# UNITED STATES PATENT AND TRADEMARK OFFICE

APPLICATION NO.	FILING DATE	FIRST NAMED INVENTOR	ATTORNEY DOCKET NO.	CONFIRMATION NO.
10/574,452	04/04/2006	Peter Flisikowski	NL 031202	9326

## Office Action Summary

## **DETAILED ACTION**

Fig. 1 & 8 - Window & X-ray device – U.S. Patent Application Publication 2002/0048345 to Bachmann et al.

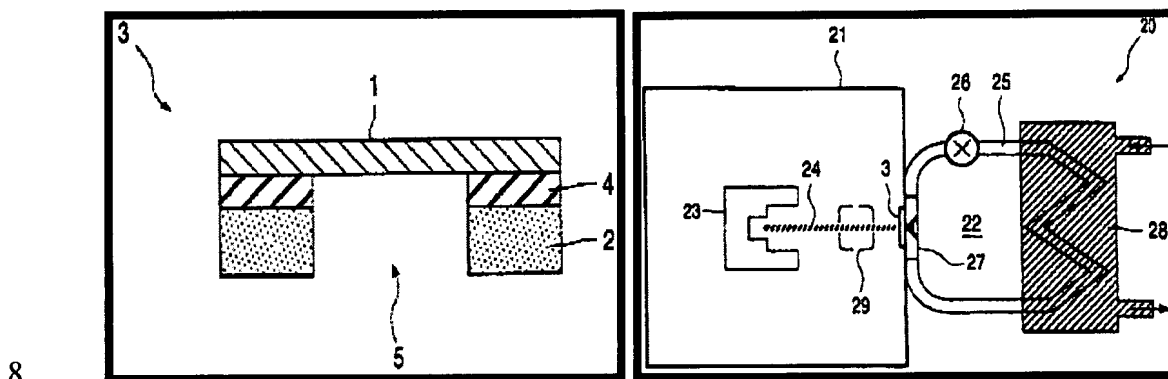
9. As per claims 1, 2 and 10, Bachmann et al. disclose a method of manufacturing a window (3), comprising the steps of: providing on a surface of a carrier element (2) a window foil (1), the surface of the carrier element having a receiving area, receiving a soldering material (4); the soldering material (4) fixing the window foil (1) to the carrier element (2); the carrier element (2) further comprising a through hole (5) for the transmission of electrons; placing the window foil (1) on top of the surface and heating the soldering material (4) to affix the window foil (1) to the surface (see Fig. 1, shown above; see also para. [0013]).

10. As per claims 11-12, Bachmann et al. disclose a window further comprising: an X-ray device (20), having an electron source (23), a target (22) and window (3); the window (3) being located between the electron source (23) and target (22) – (see Fig. 8, shown above; see also para. [0037]).
